**Economic Commission for Europe****Inland Transport Committee****World Forum for Harmonization of Vehicle Regulations****Working Party on Noise****Sixty-fourth session**

Item 6 of the provisional agenda

**Regulation No. 92 (Replacement exhaust silencing systems for motorcycles)****Proposal for a Supplement to Regulation No. 92****Submitted by the expert from the European Commission\***

Figure 1  
Test apparatus for conditioning by pulsation

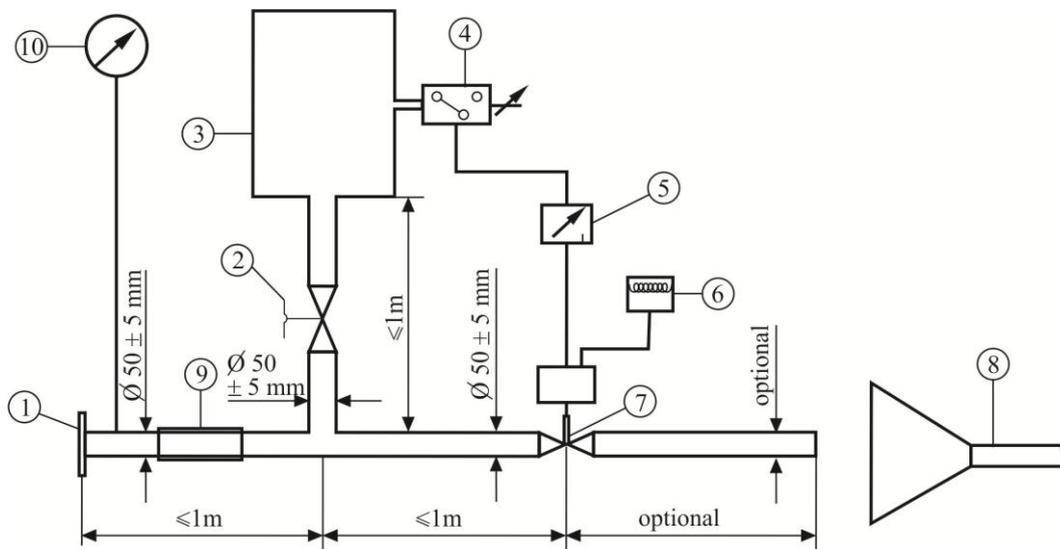
## 2. ~~Conditioning by pulsation~~

~~The test apparatus, a detailed diagram of which is shown in Figure 1, is fitted at the outlet of the exhaust system. Any other apparatus providing equivalent results is acceptable.~~

2.2. ~~The test equipment shall be adjusted so that the flow of exhaust gases is alternatively interrupted and restored 2,500 times by a rapid action valve.~~

2.3. ~~The valve shall open when the exhaust gas back pressure, measured at least 100 mm downstream of the intake flange, reaches a value of between 0.35 and 0.40 bar. Should such a figure be unattainable because of the engine characteristics, the valve shall open when the gas back pressure reaches a level equivalent to 90 per cent of the maximum that can be measured before the engine stops. It shall close when this pressure does not differ by more than 10 per cent from its stabilized value with the valve open.~~
